NOTICE OF NON-PERFORMANCE

INSPECTION REPORT

Electrical Corporation:	Pacific Gas and Electric Company
Report Number:	PAD_PGE_BKA_20260114_1210
Inspector:	Babak Kaviani
WMP Year Inspected:	2025
Quarterly Data Report (QDR) Referenced:	Quarter 3 (Q3)
Inspection Selection:	Energy Safety viewed the contents of the Q3 QDR and performed an analysis that resulted in the selection of the WMP initiatives and locations referenced in this report.
Relevant WMP Initiative(s):	8.1.7.2 - Open Work Orders - Distribution Tags
Date of Inspection:	January 14, 2026
City and/or County of Inspection:	North Fork, Madera County
Inspection Purpose:	Assess the accuracy of Pacific Gas and Electric Company’s QDR data, completeness of its work, and performance of WMP requirements.

Deficiency 1

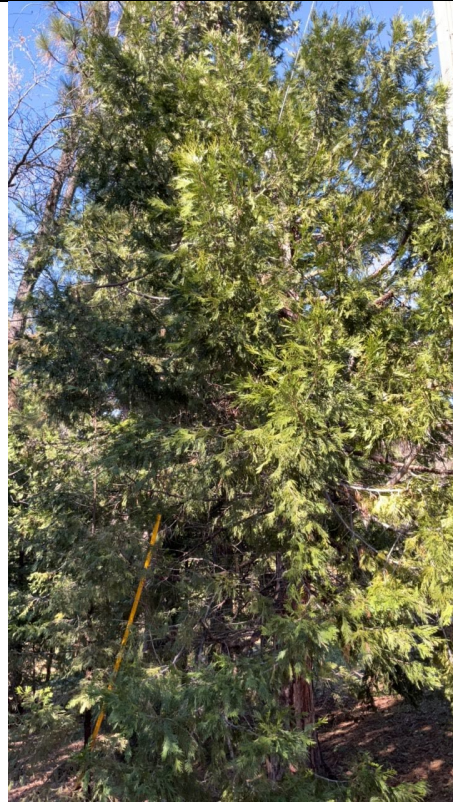
On Pole ID 122112097, Grid Hardening ID 123929392 at 37.2746654733089, -119.579994859697, the inspector observed that vegetation was in contact with the pole and guy wire above the insulator, despite PG&E's Field Notes indicating that vegetation trimming above the insulator had been completed in August 2025. The inspector's observation is documented in Deficiency 1 photographs, which are attachments to this report. Photo numbers IA1Img1, IA1Img2, IA1Img3, IA1Img4, IA1Img5, IA1Img6, and IA1Img7 depict vegetation in contact with the pole and guy wire above the insulator. In the 2025 Q3 Quarterly Data Report submission, PG&E reported that work on WMP initiative 8.1.7.2 – Open Work Orders – Distribution Tags was completed at this location.

1. Overgrown vegetation on the guy wire was reported as trimmed in August 2025.
2. Vegetation observed in contact with the pole and guy wire above the insulator.

IA1Img2: Vegetation in contact with the pole and guy wire

IA1Img3: Vegetation in contact with the pole and guy wire above the insulator

Deficiency 1. Energy Safety observed that in implementing 2025 WMP initiative 8.1.7.2 - Open Work Orders - Distribution Tags, PG&E failed to complete work on open work orders - distribution tags on Pole ID 122112097, Grid Hardening ID 123929392 at coordinates 37.2746654733089, -119.579994859697. Energy Safety considers this non-performance to be in the Minor risk category. PG&E must complete a corrective action for this deficiency by 12 months from the date of this notice.
